Re: OSU College of Engineering

I am enclosing a drawing of the revised locations for the kinetic sculptures planned for the atrium of the Kelley Building according to the discussion we had over the phone several weeks ago.

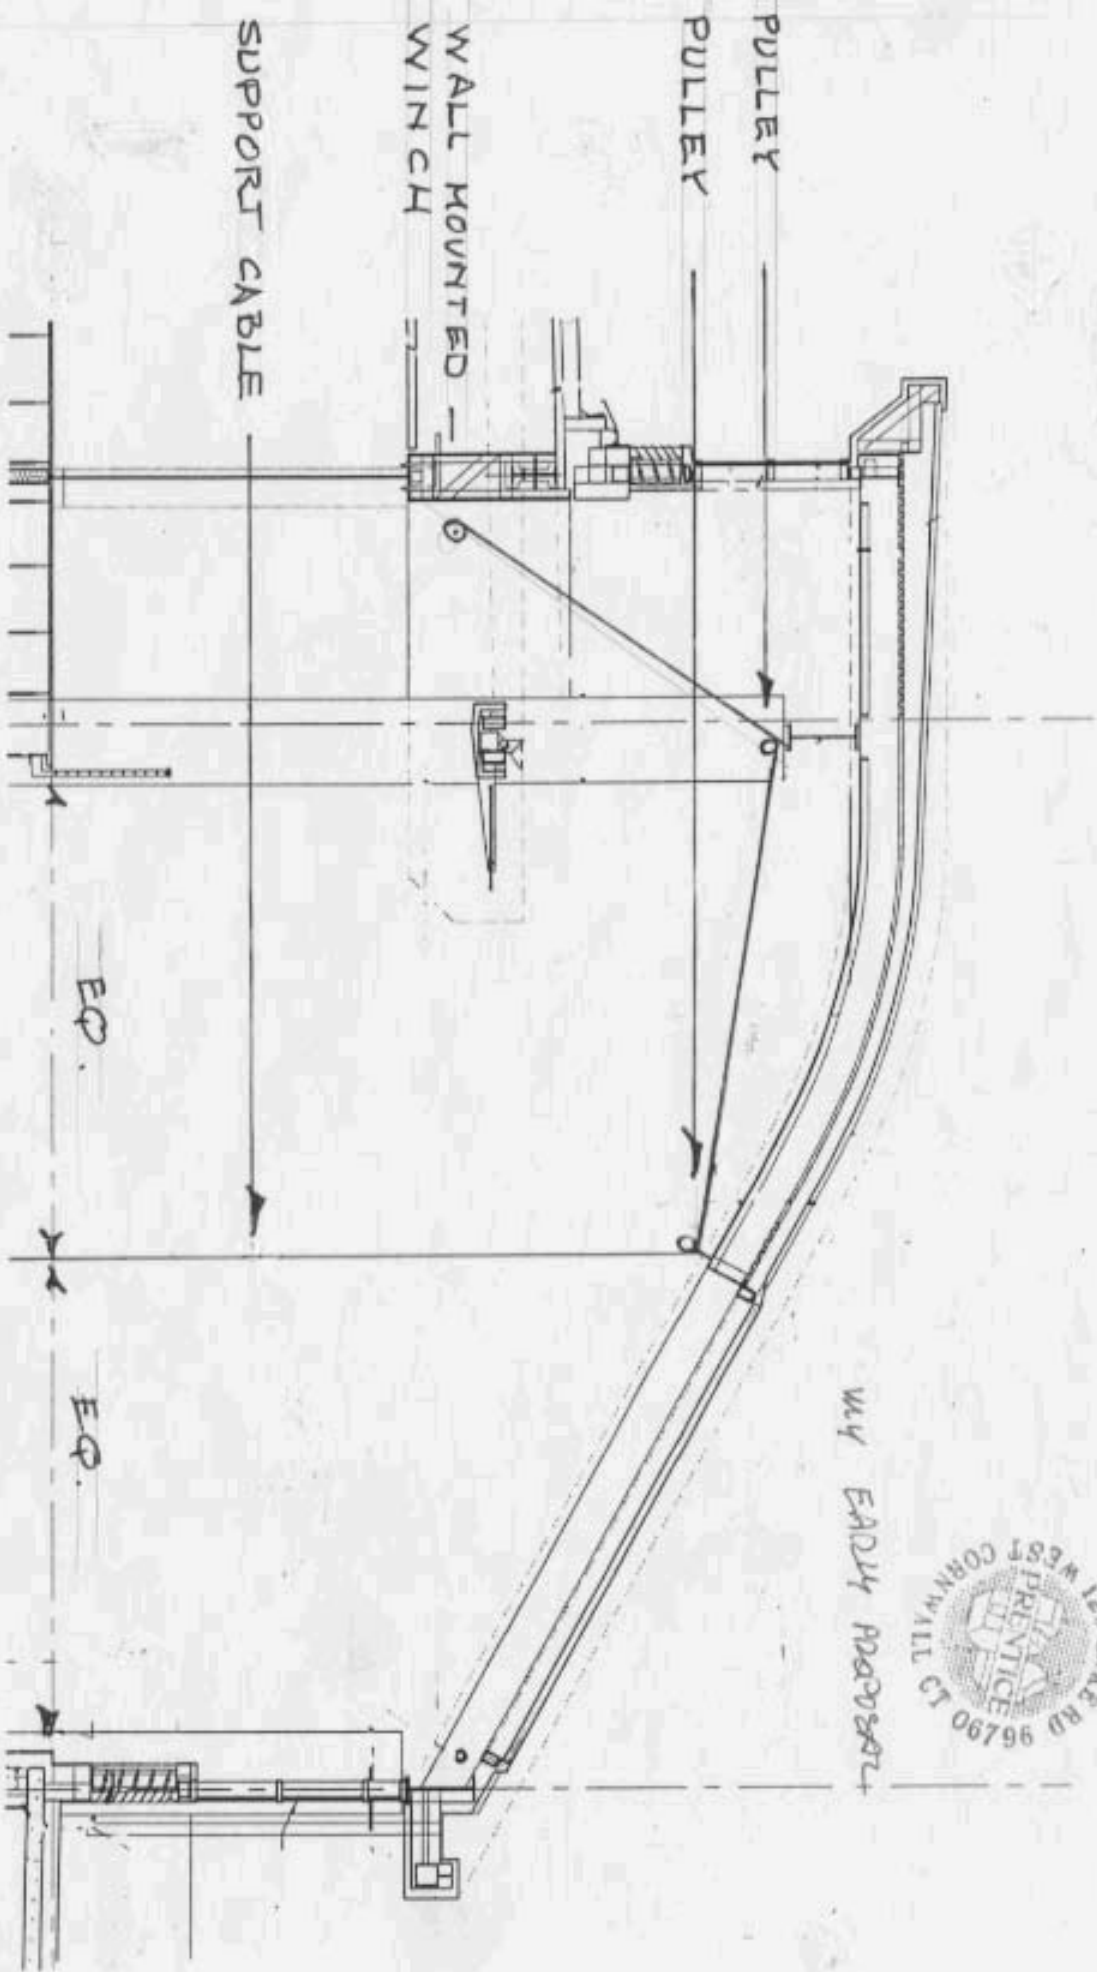
The basic idea is to keep them generally fairly low in the space and have them rise towards the stair landings. The letters on the section designate the individual sails as described in the presentation brochure but given the desire to have them built with a more open weave, the weights and proportions will change somewhat when we get into fabrication. With more space between the individual plates the sails should have slightly larger overall dimensions.

With the winch system, details of which I faxed on 6/17/04, it will be easily possible to make final adjustments of height during the installation. I have indicated the lowest sails to be 13 feet from the finished floor but this might be affected by the ficus trees
